PHAP15-00021

Date: July 6, 2015
Application Type: Certificate of Appropriateness
Property Owner: Robert and Amy O'Rourke
Representative: Alberto Alcantar
Legal Description: Being 7 Sunset Heights 56 To 59, City of El Paso, El Paso County, Texas
Historic District: Sunset Heights
Location: 1100 Los Angeles Drive
Representative District: #8
Existing Zoning: R-4/H (Residential/Historic)
Year Built: 1904
Historic Status: Landmark
Request: Certificate of Appropriateness for the demolition and reconstruction of an addition and the modification of a window opening into a door
Application Filed: 6/22/2015
45 Day Expiration: 8/6/2015

ITEM #2

Certificate of Appropriateness for the demolition and reconstruction of an addition and the modification of a window opening into a door

EXISTING AND PROPOSED PLANS

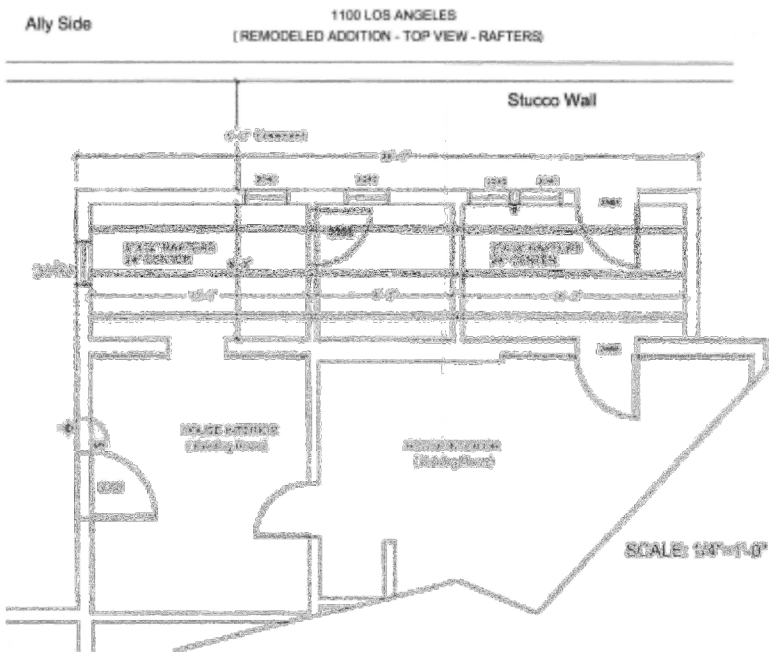
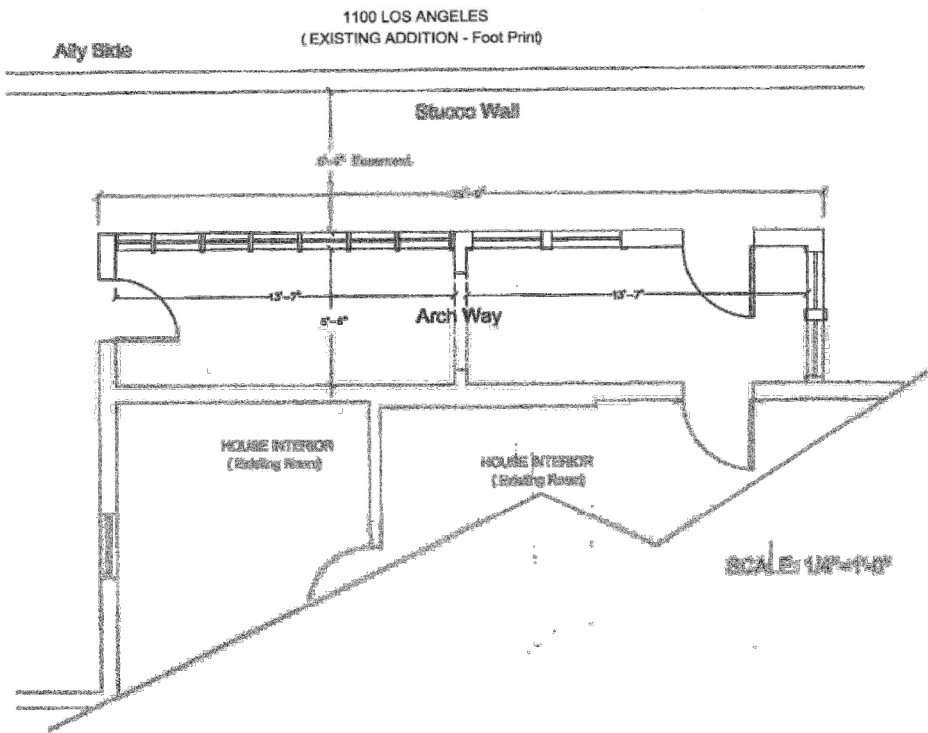
The Historic Preservation Office recommends APPROVAL of the proposed scope of work based on the following recommendations:
